Intel Atom[®] Processor E3800

Specification Update

(Formerly Bay Trail -I SoC)

October 2017

2. ILB_RTC_TEST# and ILB_RTC_RST# RC Time Delay Calculation Formula

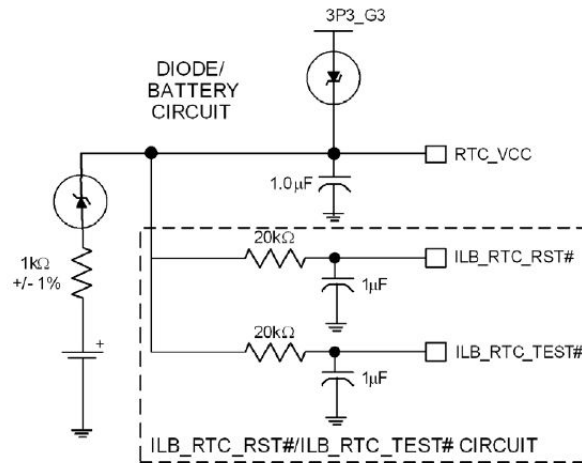
The RC delay between RTC_VCC to ILB_RTC_TEST and ILB_RTC_RST, Figure 21-4 in Section 21.2.3 of the PDG (Doc ID #512379) is obtained by using the formula $t = -\ln((RTC_VCC - V_{ih\ min})/RTC_VCC) * R * C$ and the added circuit is as follows:

The SoC RTC requires some additional external circuitry. The ILB_RTC_RST# and ILB_RTC_TEST# signals are used to reset the RTC well. The external capacitor and the external resistor between ILB_RTC_RST#/ILB_RTC_TEST# and RTC battery (VBAT) were selected to create an RC time delay, such that ILB_RTC_RST# and ILB_RTC_TEST# go high sometime after the battery voltage is valid. The RC time delay should be in the range of 18-25 ms. When ILB_RTC_TEST# is asserted, bit 2 (RTC_PWR_STS) in the GEN_PMCON_1 (General PM Configuration 1) register is set to 1, and remains set until software clears it. Hence, when the system boots, the BIOS recognizes that the RTC battery is removed.
